Reply
to
Submissions
and Preferred
Project
Report

09-0028 Parklands

A report with respect to submissions to
the exhibition of the Environmental
Assessment including a Preferred
Project description and updates to the
project Statement of Commitments.

Prepared for:
North Byron Parklands
Billinudgel Property Pty Ltd

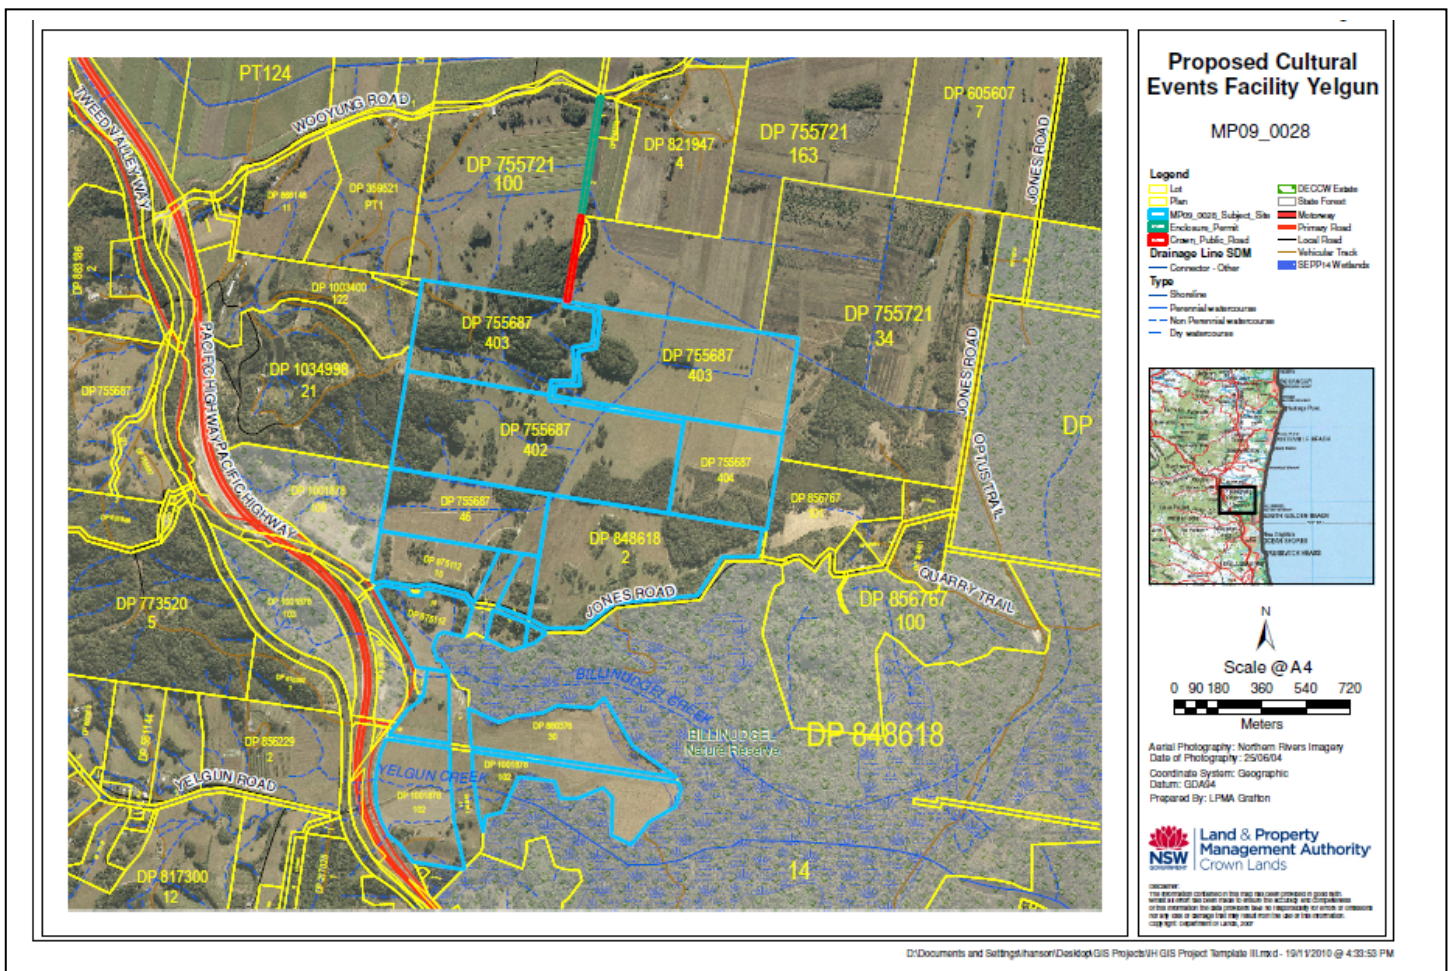
- However, a Crown public road still adjoins the northern boundary of Lot 403, as depicted in Figure 1, which is identified in the EA as providing emergency vehicle access from Wooyung Road to the proposed development site.

- A section of this Crown public road is held under an Enclosure Permit (under Section 61 of the *Crown Lands Act 1989*), as depicted in Figure 1.
- According to the EA "A road reserve with a farm access road of approximately 850 metres in length connects the northern property boundary with Wooyung Road" and "The proposal does not involve use of this access connection, other than for emergency vehicle use" (Page 126).

The Crown public road adjoining the northern boundary of the Parklands site and connecting through to Wooyung Road was proposed in the EA as only being used in instances where emergency vehicles required access or egress from this direction. Application has been made to close and purchase this Crown road reserve (Reference W480961). Emergency vehicle access has been arranged with the adjoining private land holder to the north-east (see **Appendix C**).
